PROJECT COMMENTS

PROJECT NUMBER: SP2026-027
PROJECT NAME: Site Plan for Texas Social Driving Range & Parking PH 1
SITE ADDRESS/LOCATIONS: 1091 Rayburn Way, Rockwall, TX, 75032

DEPARTMENT	REVIEWER	DATE OF REVIEW	STATUS OF PROJECT
PLANNING	Henry Lee	07/22/2026	Needs Review

DEPARTMENT	REVIEWER	DATE OF REVIEW	STATUS OF PROJECT
ENGINEERING	Madelyn Kuhn	07/21/2026	Approved w/ Comments

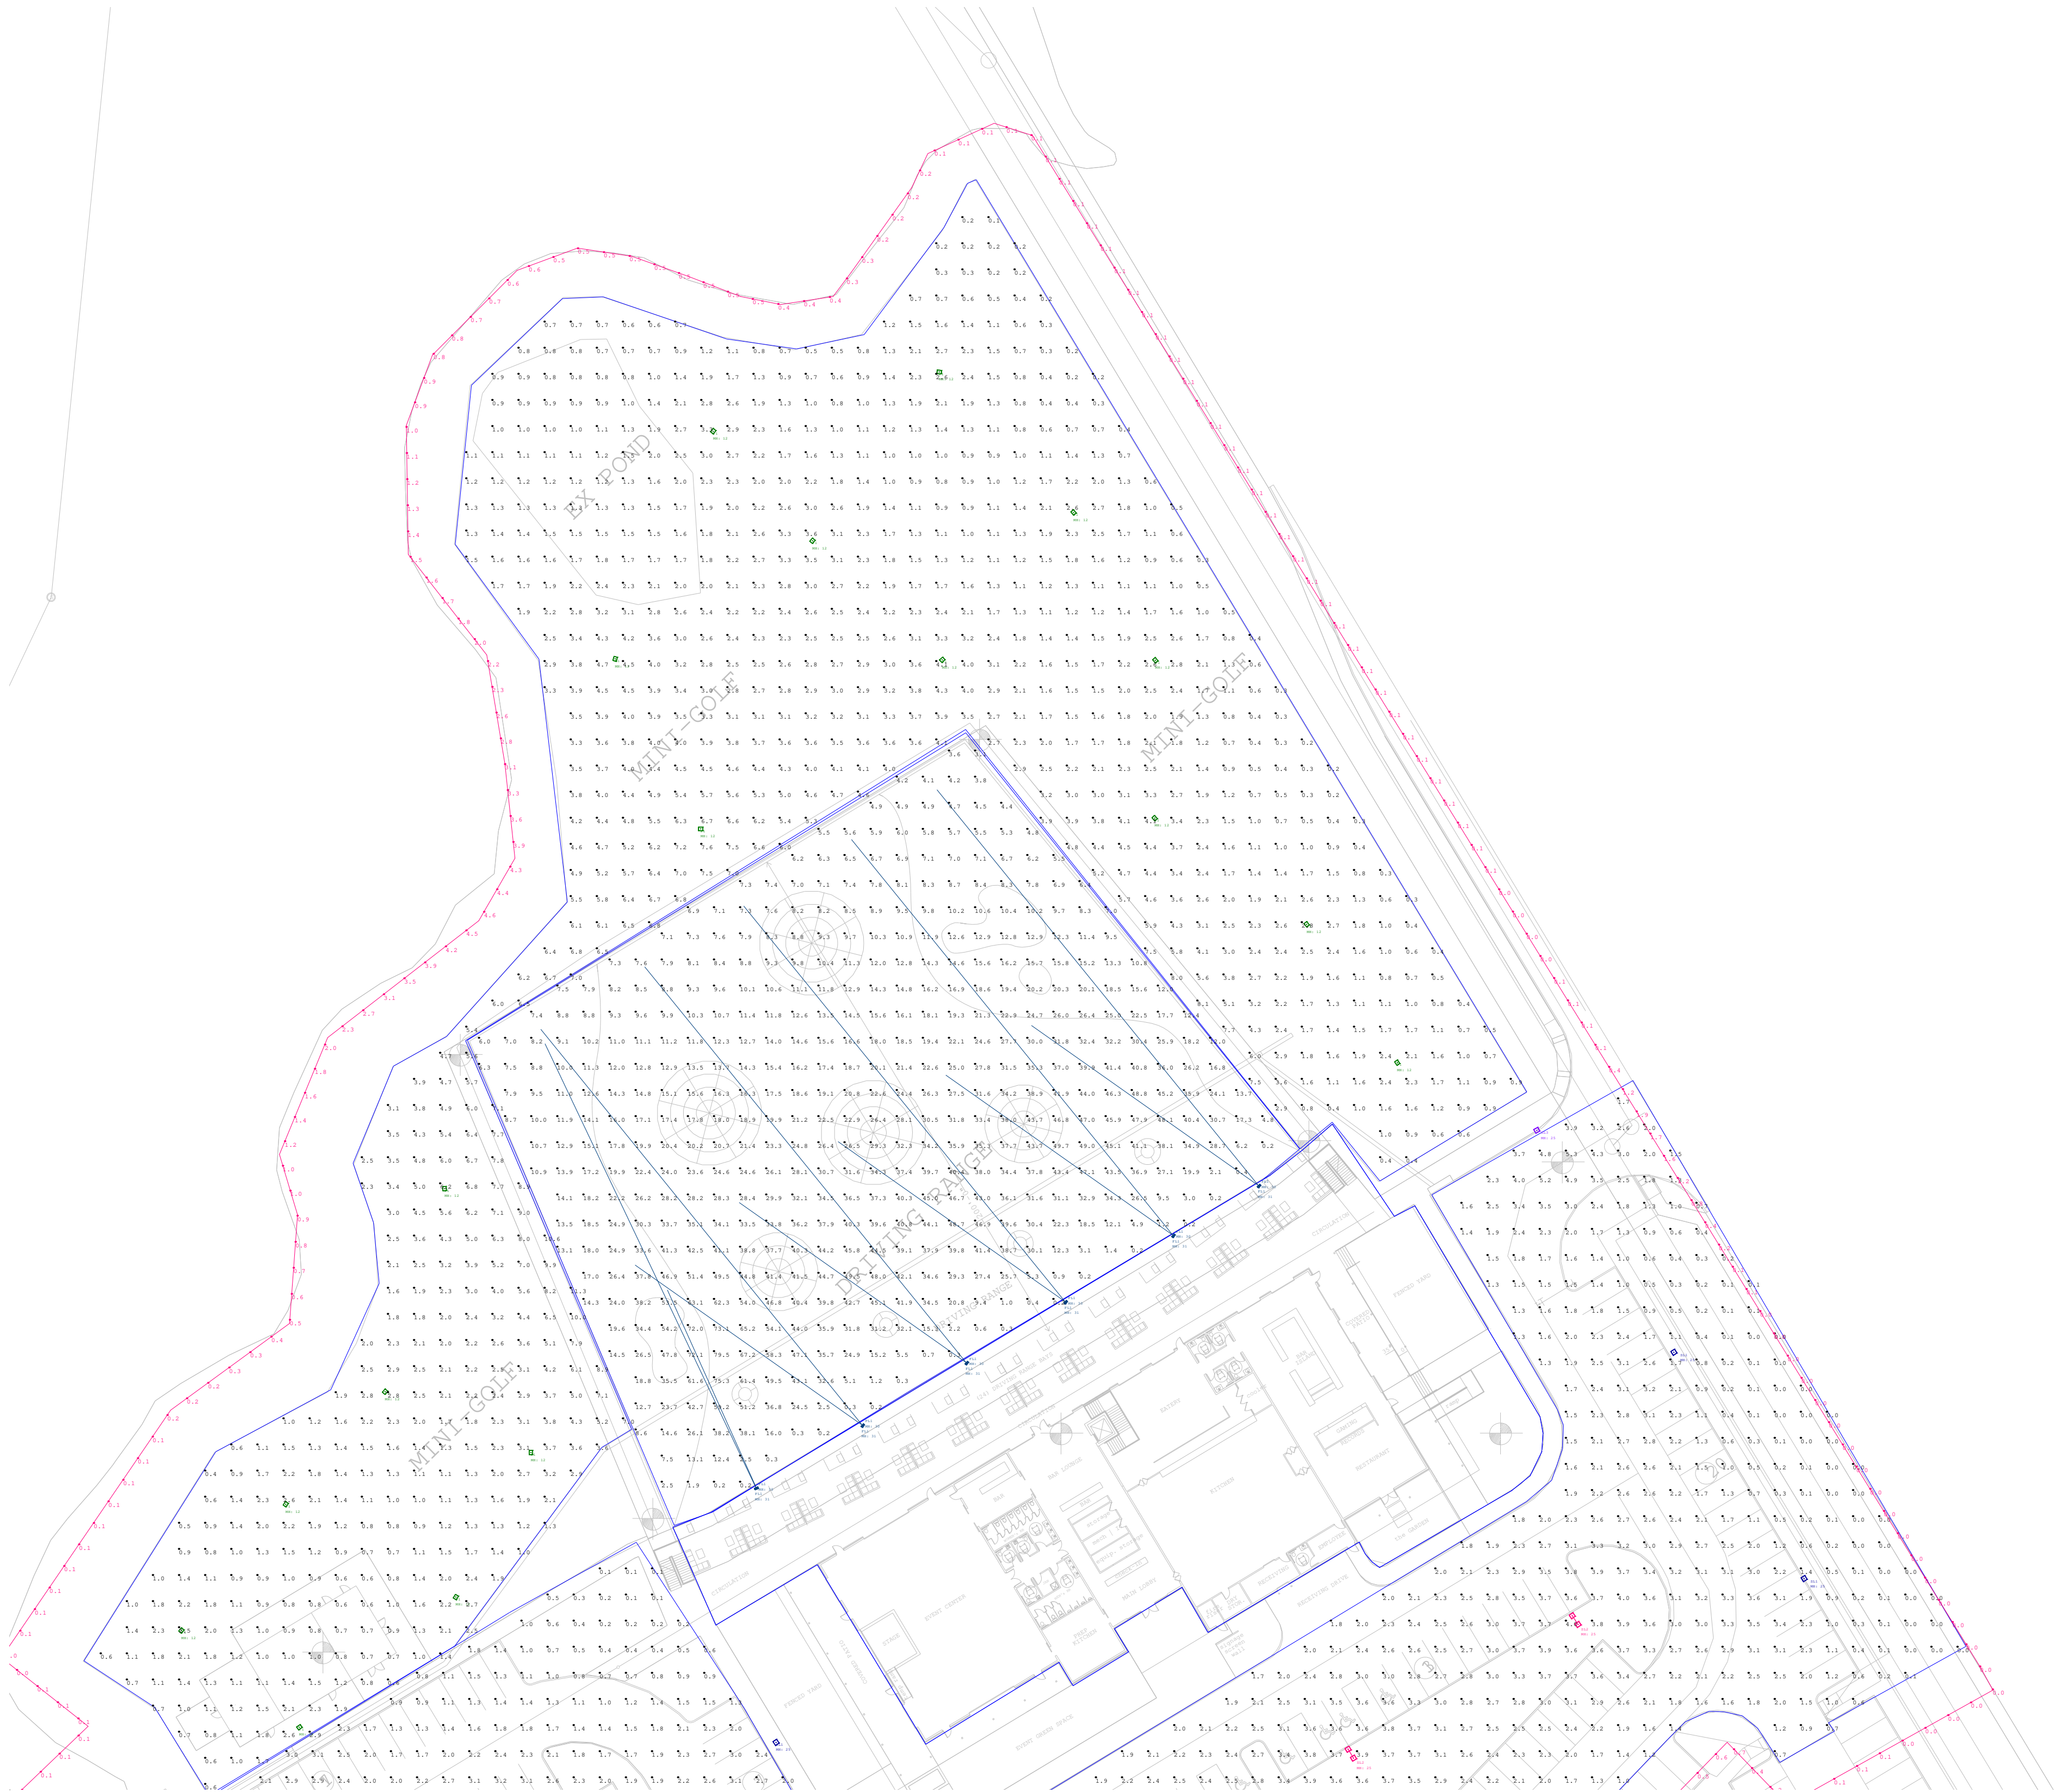
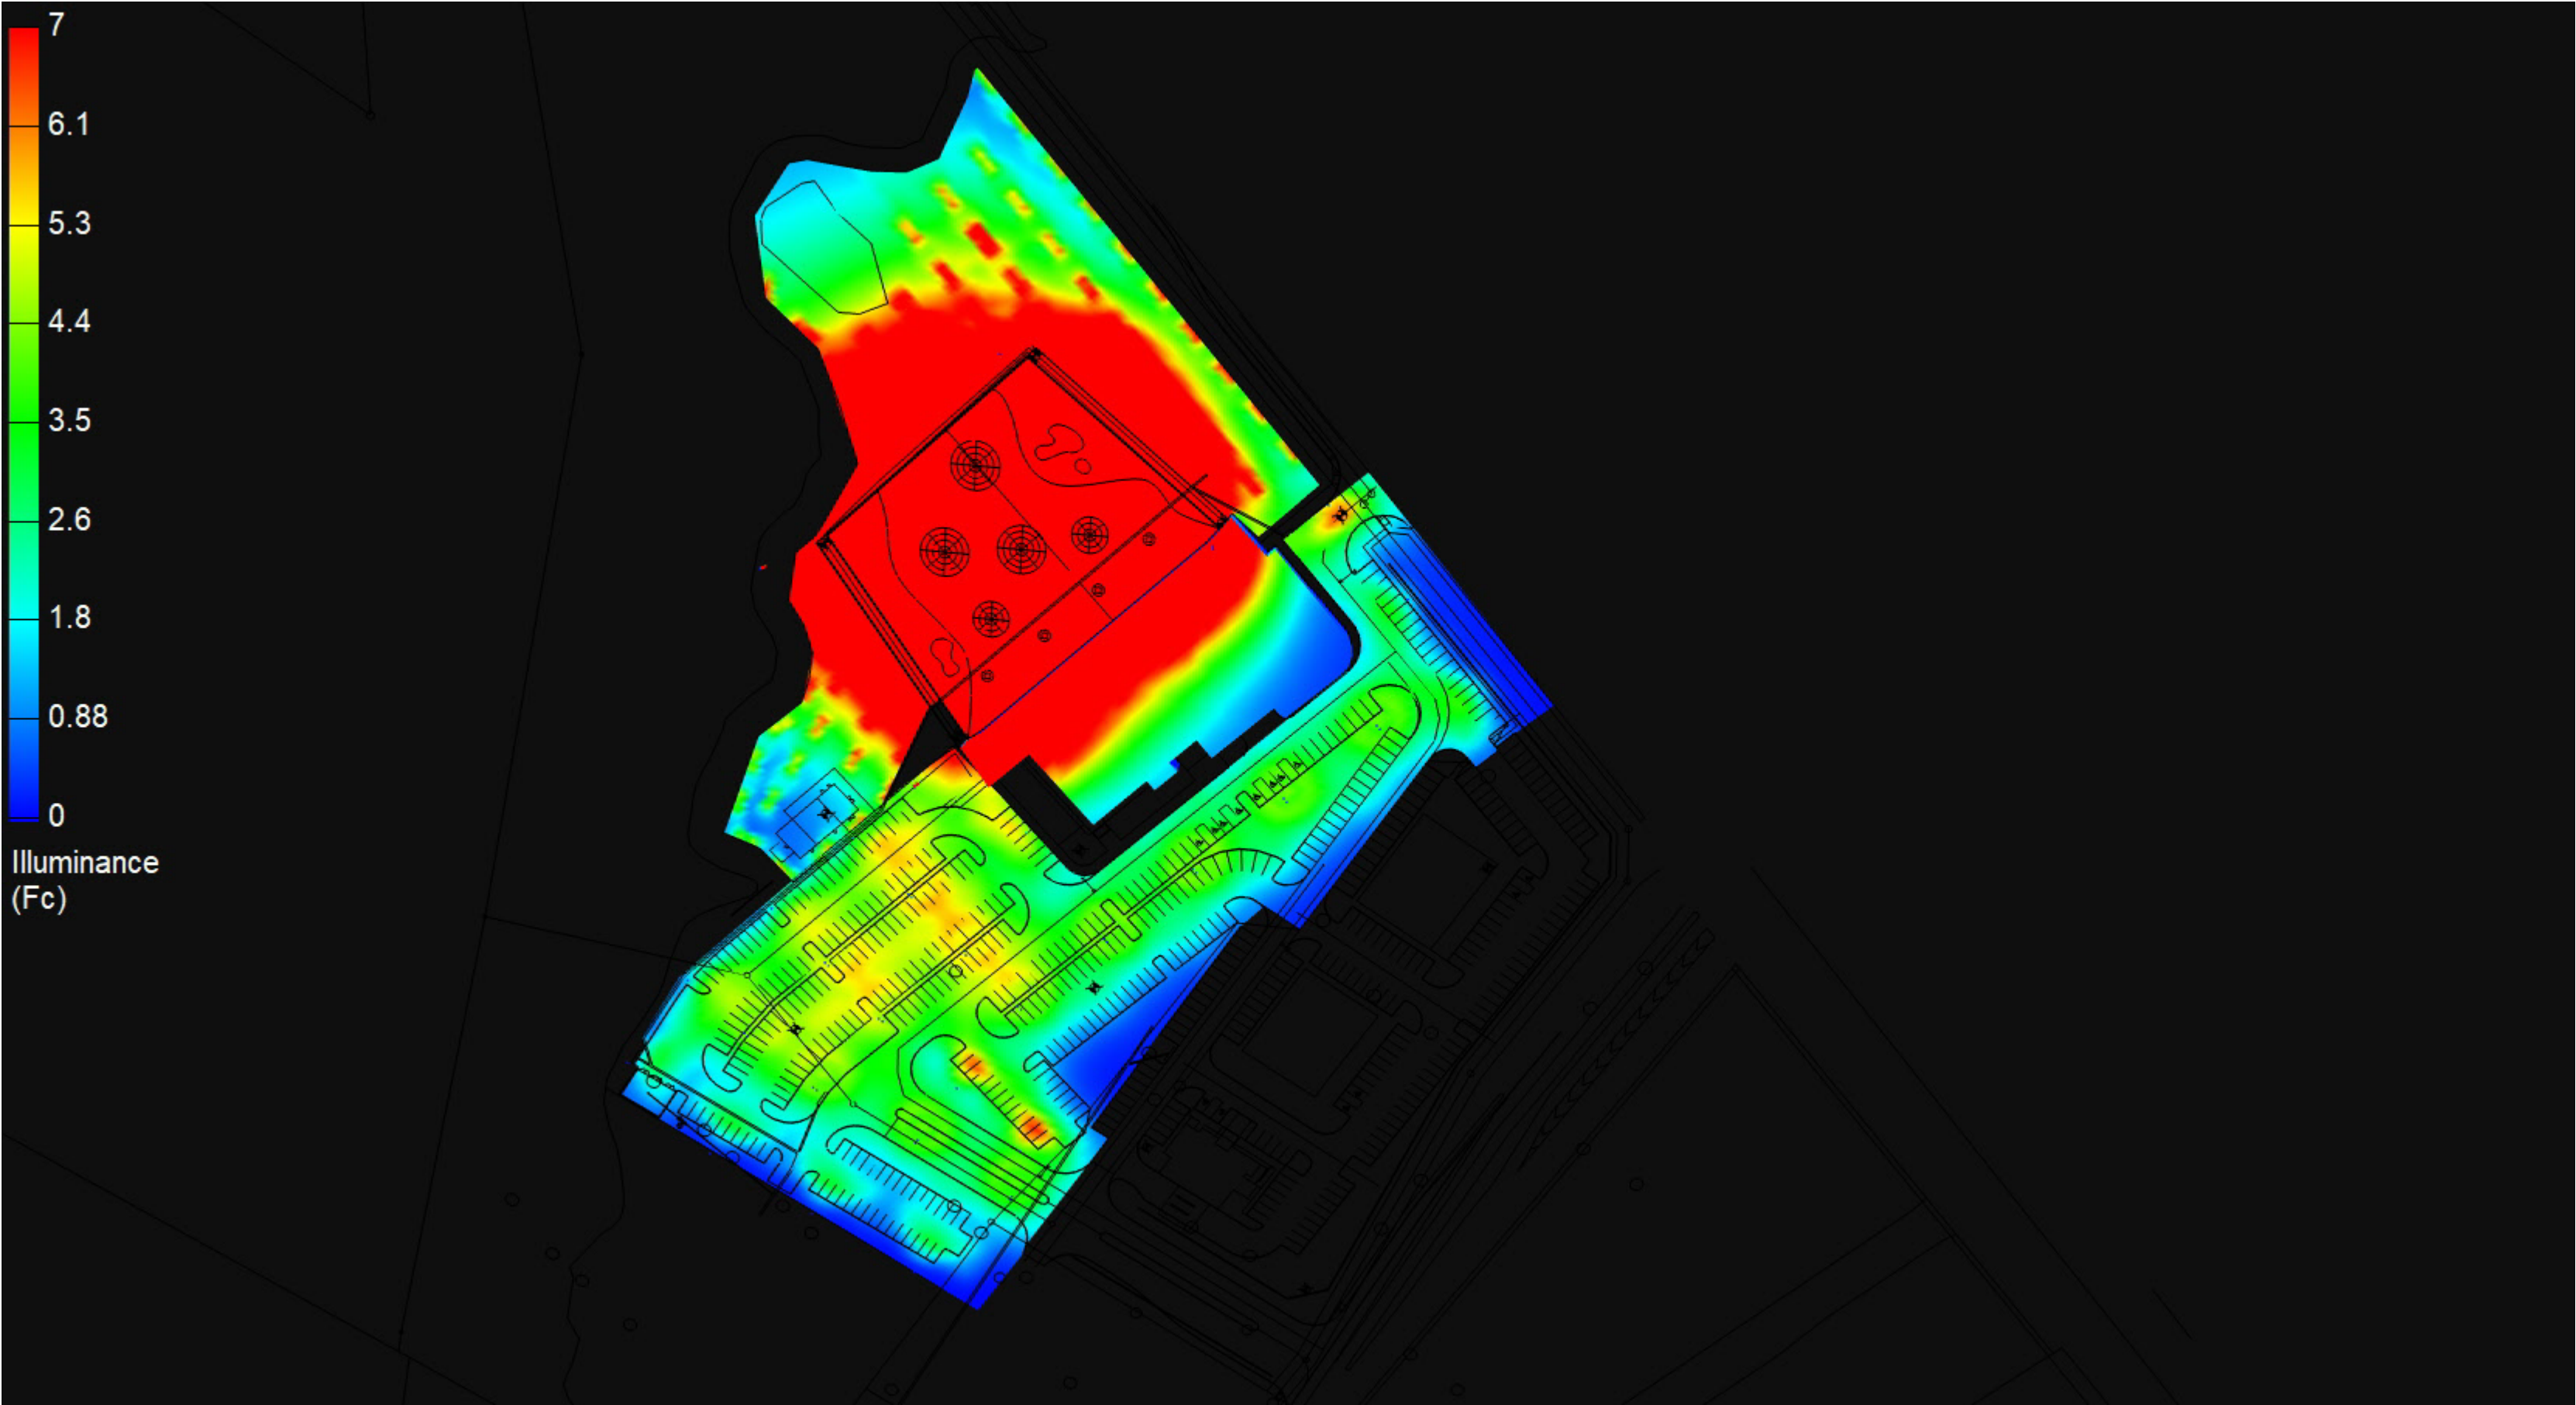
- (2) The light fixtures in the parking areas and on the building cannot exceed 20-feet in height. For the driving range, please indicate the mounting height of the light fixtures. In addition, the light levels cannot exceed 0.2 FC at any property line, and along S. Goliad Street staff would prefer the FC be 0.0 FC if possible. As noted in the variance letter the light levels over 20 FC for the driving range will be an exception. (Subsection 03.03, of Article 07, UDC)

- (3) Please extend the light level measurements to the west until they reach 0.2 FC. In addition, please extend the light level heat map to the west until it reaches 0.0 FC. (Subsection 03.03, of Article 07, UDC)

- (4) All lighting must be fully shielded and oriented downward. (Subsection 03.03, of Article 07, UDC)
